NEWLEAF COMMUNITIES
PROJECT BONNYRIGG
Concept Plan & Stage 1 Project
Application
Proposed by Bonnyrigg
Partnerships - Becton Property
Group Limited

MP06\_0046 MOD 2

Modification of Minister's Approval Section 75W of the Environmental Planning and Assessment Act 1979

New Leaf Living Communities Project Bonnyrigg Director-General's Report Concept Plan & Stage 1 Project Application Modification Major Project 06\_046 MOD 2

Fig 1: Plan on Page 39 of Masterplan showing homes in private ownership (site coloured orange).

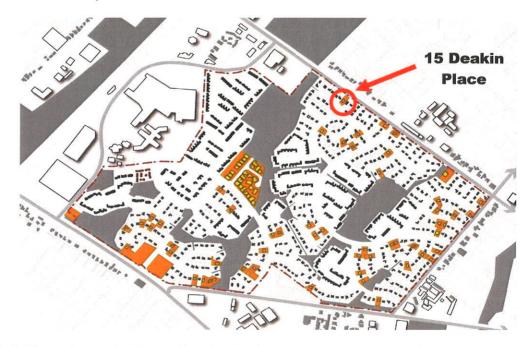
- Include 15 Deakin Place (TAG G) within the development.
  - The property is already within the boundaries of Stage 2 of the approved Concept Plan except that it is identified on page 39 of the Masterplan as a 'home in private ownership' (see Figure 1 below); and
- ii. Allow detached dwellings on 8.5m wide lots for future Stages 2-18.
  - There are 7 detached dwellings in Stage 2 with a reduced width of 8.5m, which represents 7% of the total number of dwellings proposed for this stage and 25% of the proposed 28 detached dwellings.

- i. The plans on Pages 39, 43, 52 and 53 of the Masterplan showing 'homes in private ownership' has been amended to delete reference to 15 Deakin Place and the Introduction on Page 9 has been amended as follows (amendments in bold):
  - The Masterplan retains 20 Housing NSW owned villas and 86 85 privately owned homes. One privately owned home has been purchased and it is anticipated that additional homes may be considered for purchase where appropriate and feasible.

The inclusion of this property is supported as new development built on site would have the same form and style as surrounding buildings once Stage 2 is completed. Potential contamination issues (if any) associated with 15 Deakin Place would be addressed as part of the Stage 2 Project Application, in accordance with Condition A3(1) of Schedule 2 of MP\_0046 which requires the submission of a detailed contamination assessment for each stage of the development.
